REPLACEMENT: PA939A SUPERSEDES PA939

PREMIUM WATER PUMPS

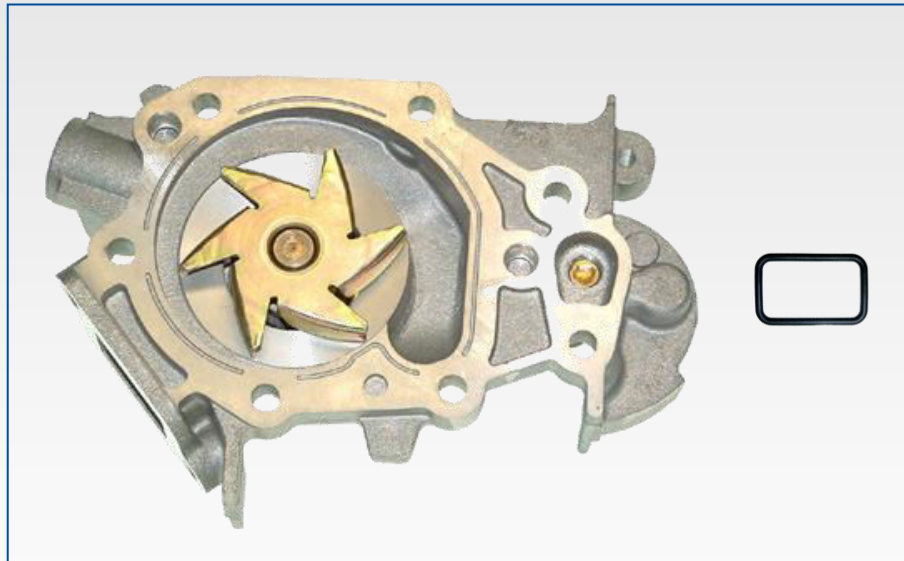
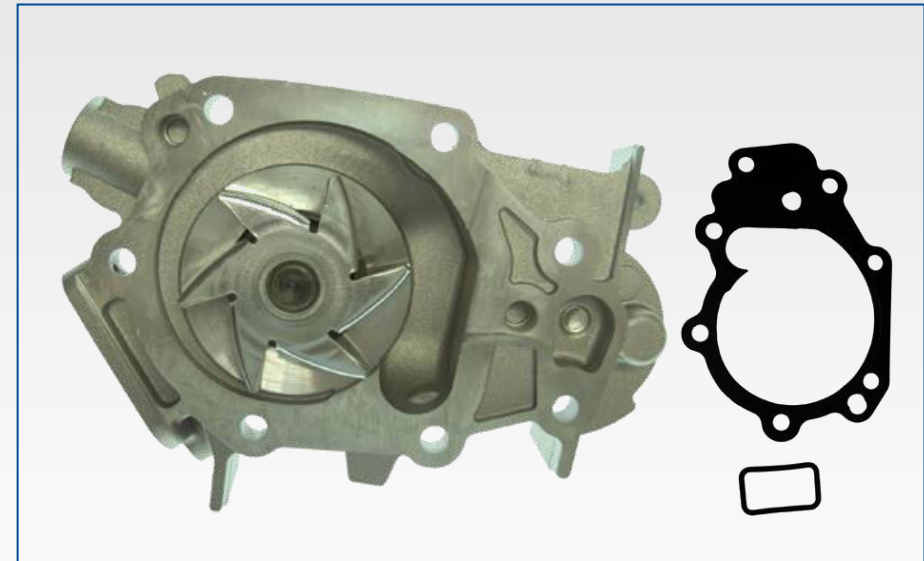
Saleri reference PA939 has been updated through the introduction of a metal rubber gasket, in order to grant a better tightness during the fitting phase on the engine. Therefore the use of sealant is no longer needed. The new price is indicated in the order confirmation.
